**Re:** Case No. 21-508-EL-BGA, In the Matter of the Application of Madison Fields Solar Project, LLC, for an Amendment to its Certificate Issued in Case No. 19-1881-EL-BGN to Extend the Facility Footprint Within the Project Area.

**Response to Second Data Request From Staff of the Ohio Power Siting Board**

**MADISON FIELDS SOLAR PROJECT, LLC 'S  
RESPONSE TO THE SECOND DATA REQUEST  
FROM THE STAFF OF THE OHIO POWER SITING BOARD**

SHEET:  
**OPSB - MADISON FIELDS AMENDMENT**

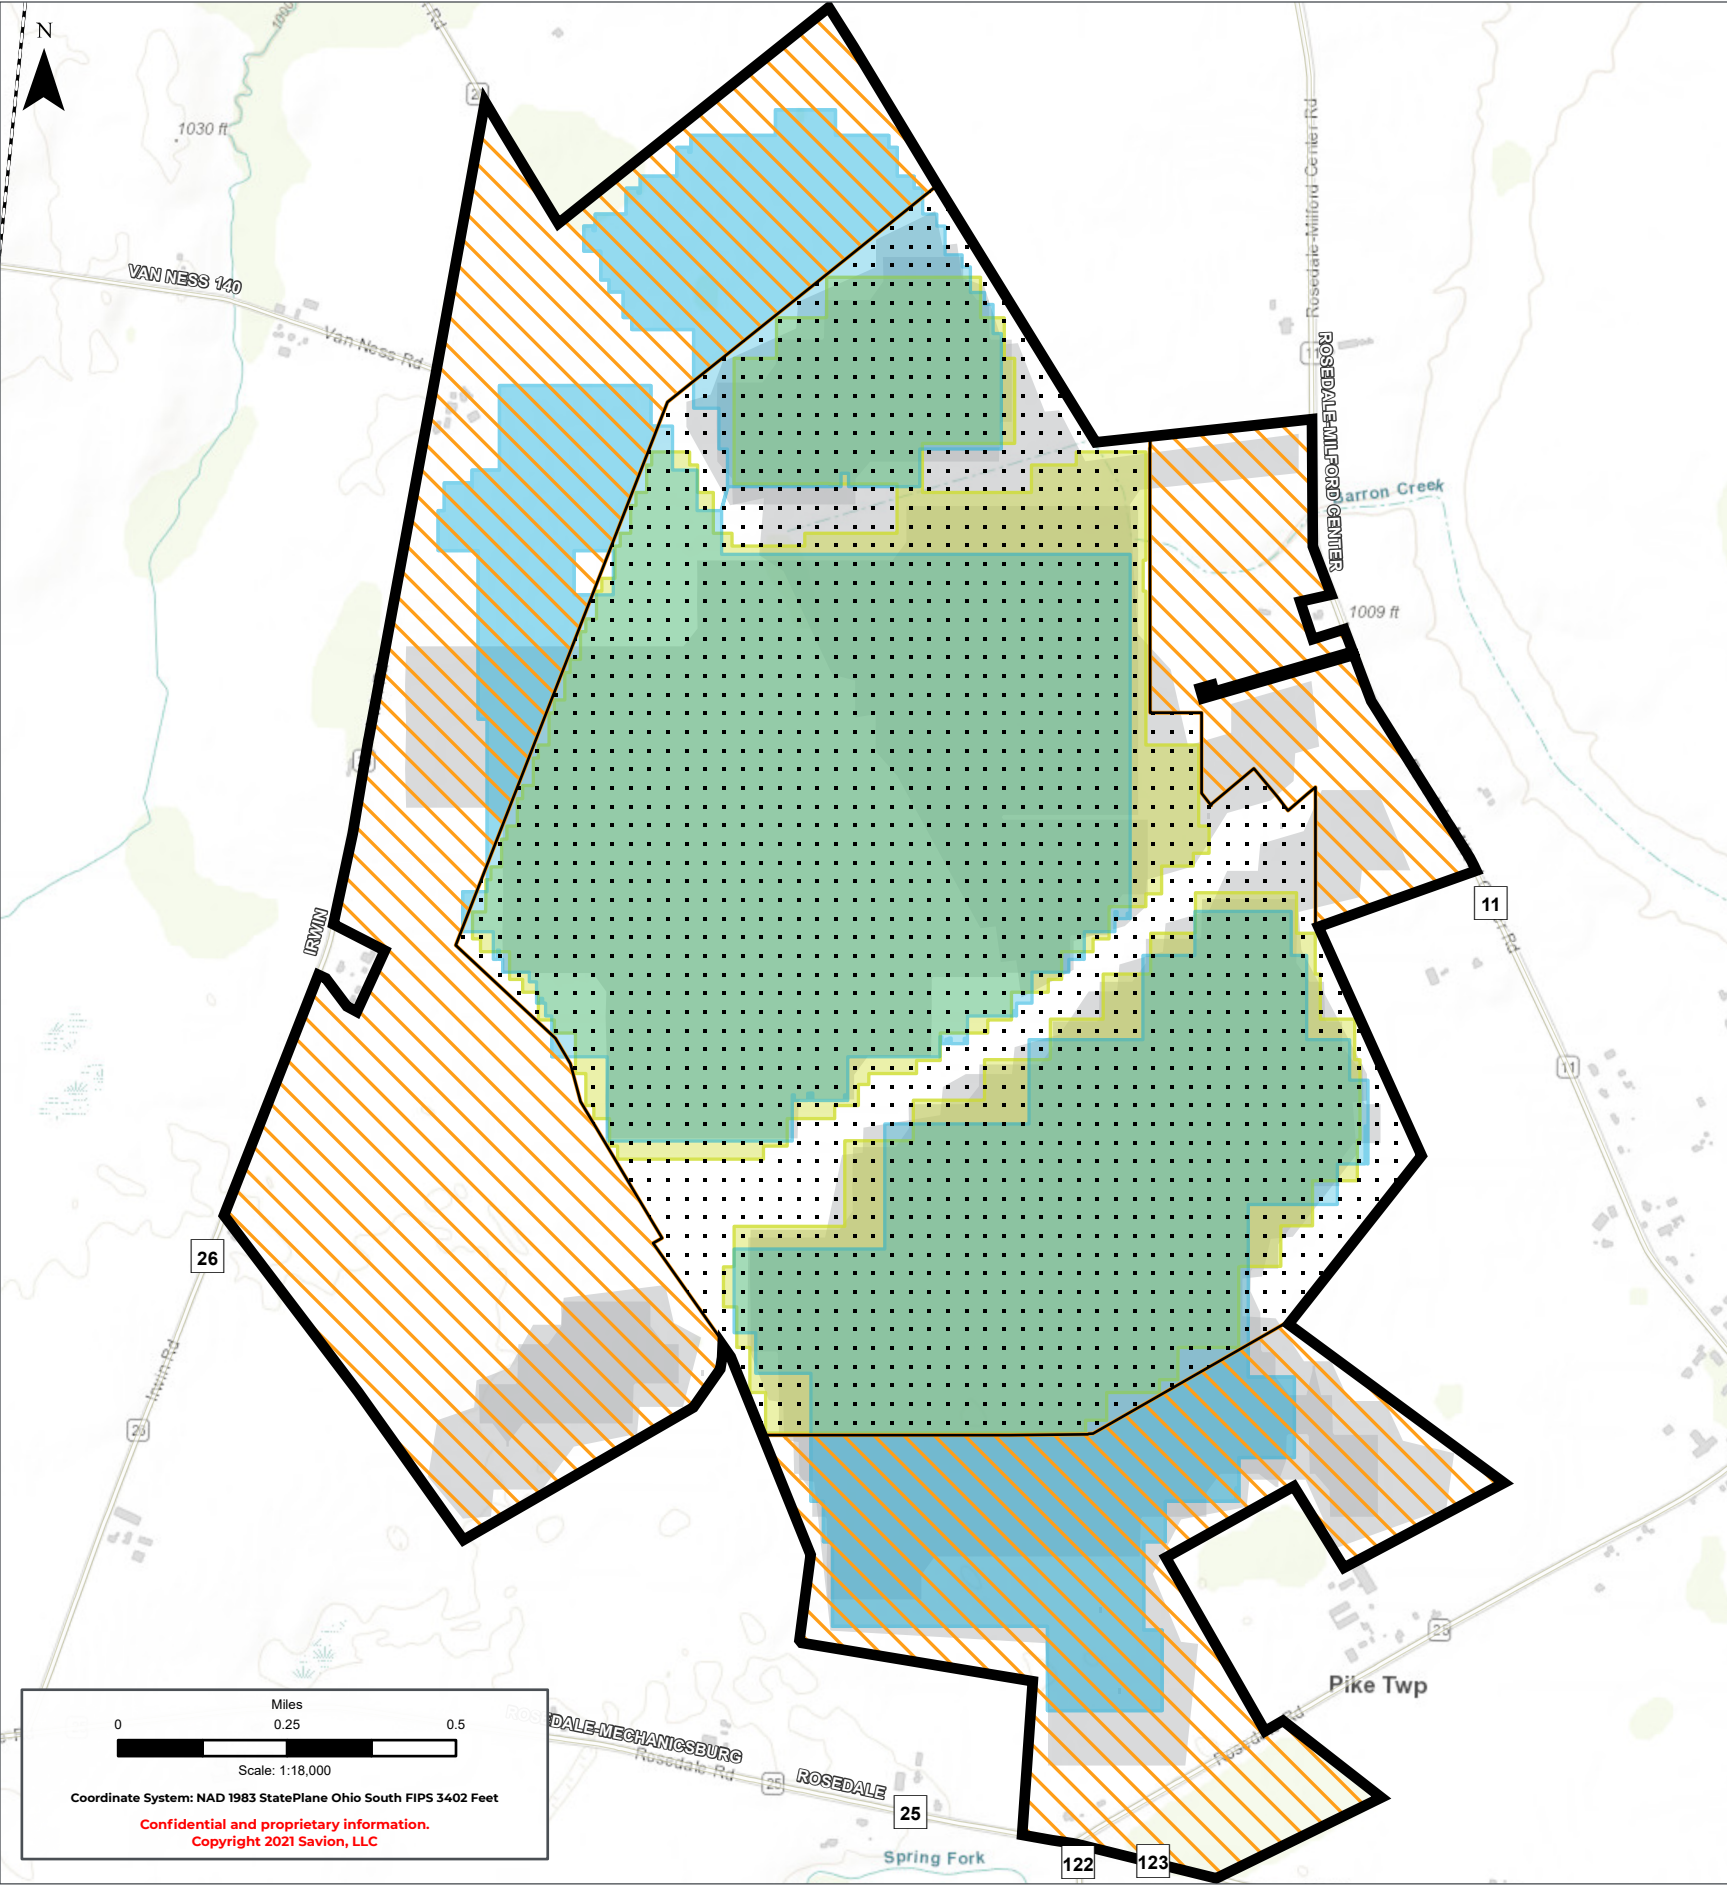
3. In Table 8-5 on page 70 of the Application for 19-1881-EL-BGN, the solar generating facility project infrastructure is contained to 1,006.4 acres. Please provide the total acreage for the layouts entitled “Likely solution” and “Possible depending module selection” as contemplated in Madison Fields Solar Project LLC filing dated 7/21/2021 in 21-0508-EL-BGA

Layout	Facility Footprint Acreage
“Likely solution”	Approx. 1,290 acres
“Possible depending module selection”	Approx. 840 acres
